Petition Number: 2016-115

From: Kelsie Anderson, PE Staff Reviewer: Rick Grochoske, PE

Rezoning Transportation Analysis Petition Number: 2016-115 General Location Identifier: 04742101, 04742102, 04742106

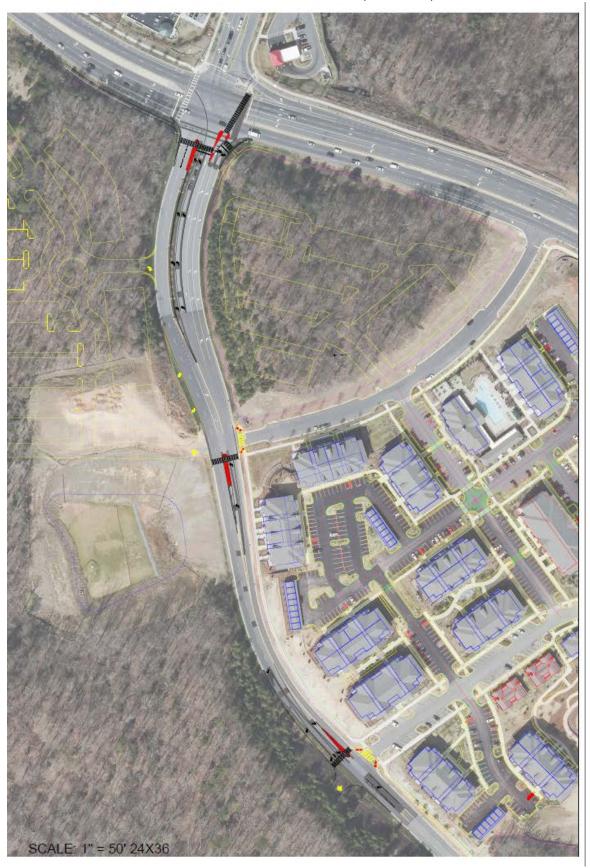
- b. Note 7d add "upon CDOT approval" to the end of the first sentence about 6' pinch points...
- 3. The petitioner should revise the site plan to show the west side Senator Royall Dr. curbline to be relocated to accommodate an additional travel lane and raised landscaped median along the site's frontage. Senator Royall Drive's future west side curbline at Alexander Village Main Dr. and Heritage Pond Dr. is 54.5' as measured from its existing double yellow centerline. (8' raised landscaped median + 4-11' travel lanes + 2.5' c/g = 54.5').

curbline. However, the petitioner should commit to accommodating the 4-lane divided with curb and gutter cross section and acknowledge that this may require curbline relocation.

- a. An additional NB Senator Royall Dr. 200' left turn storage lane w/appropriate bay taper length at Mallard Creek Church Rd. (the existing Senator Royall Dr. median must remain 8' wide to provide adequate pedestrian refuge space) (see below exhibit).

- b. Channelized NB dual right turn lanes with protected traffic signal pedestrian phasing (see below exhibit).
 - <u>8/26/16 Update:</u> Revise note 4a to include this transportation improvement and remove from 4c (iii).

- c. Traffic signal modifications to accommodate the NB dual lefts and NB dual right turns on Senator Royall Dr. NB approach at Mallard Creek Church Rd. (see exhibits below).

- 5. Include Parcel "C" Improvements The widening of Senator Royall Dr. includes an 8' raised landscaped median, and up to three (3) pedestrian refuge islands located at Alexander Village Main Dr., Heritage Pond Dr. and one to be determined during the construction permitting process (see below exhibit).

- 8/26/16 Update: CDOT has received and will consider the Senator Royall Dr. concept prepared by DRG (below, dated 8/24/2016) during the permitting process to avoid relocating the existing west side
